FRAMATOME COGEMA FUELS

Reference: Stewart Bailey to T. A. Coleman, Request For Additional Information –
Framatome Topical Report BAW-10133P, Addendum 1, "Mark-C Fuel Assembly
LOCA-Seismic Analysis," Revision 1 (TAC No. M99906), January 4, 2000

RESPONSES TO NUCLEAR REGULATORY COMMISSION QUESTIONS ON
BAW-10133P, REVISION 1, ADDENDUM 1

**Figure Q11.2 Fluid Model of the
3 x 3 Assembly Array**

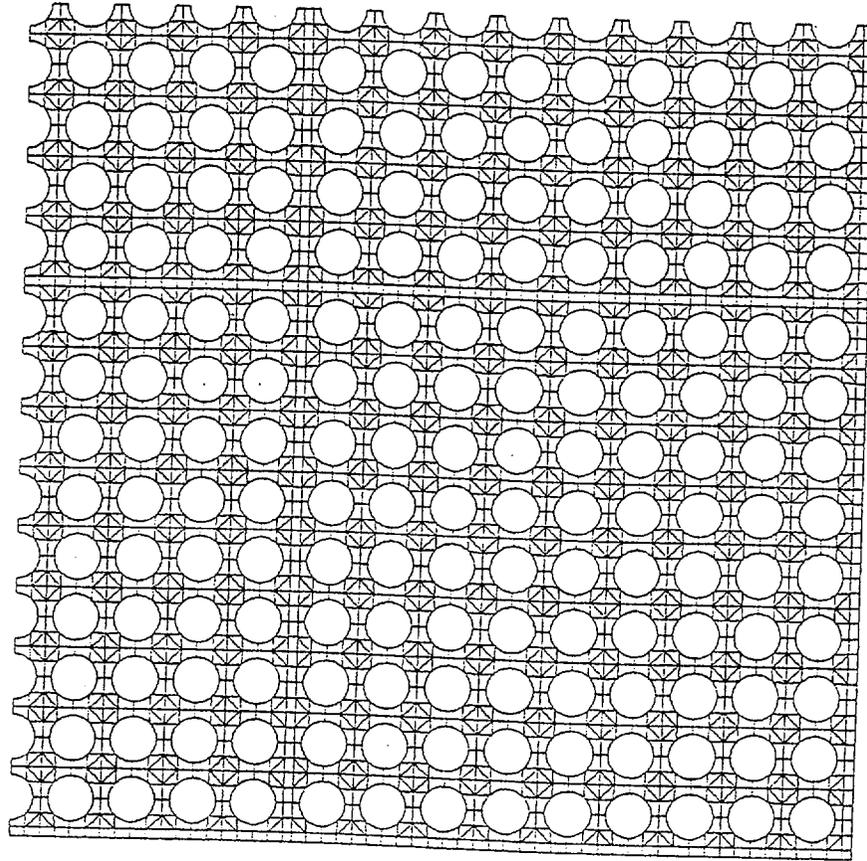
11. Page 2-6 gives non-dimensional values for the assembly added mass and the coupling with baffles for a 17X17 assembly, and states the values are "derived from a fluid model." While these values are similar to those reported in Reference 10 of Addendum 1, no detail of the fluid model was given. Please provide details of the fluid model.

The fluid model and its description are provided in Reference 1A of this document. Figure Q11.1 represents the schematic of this model, which comprises of a 3x3 array of 9x9 rod array assemblies. Figure Q11.2 represents the fluid mesh, reduced to the lower right quarter from symmetries with respect to the X and Y axes. As reported in Reference 10 of Addendum 1, the rod diameter – [b,c,d] and pitch [b,c,d] correspond to the 17x17 design. Gaps of [b,c,d] between assemblies or with the core baffles are included (average in-core value).

For the determination of the added mass term m_a , the lateral confinement of the rows along the motion direction X is obtained by accelerating simultaneously the center assemblies in the rows along X, i.e. the complete central row along Y. The

coupling term with the baffles m_c is not dependent on any hypothesis on the assembly motions, since it can be obtained from the baffle acceleration.

The dimensionless values of m_a and m_c are respectively equal to [b,c,d] and [b,c,d] for the assembly in center position. The sum is not exactly equal to [b,c,d], and the [b,c,d] difference reflects the small coupling with other assemblies. The calculated values are rounded-off and very slightly modified to fulfill exactly the consistency relationship, thus yielding the structural model values [b,c,d] and [b,c,d]. The very small decrease in absolute value with respect to those in Ref. 10 mainly results from the gap between assemblies.
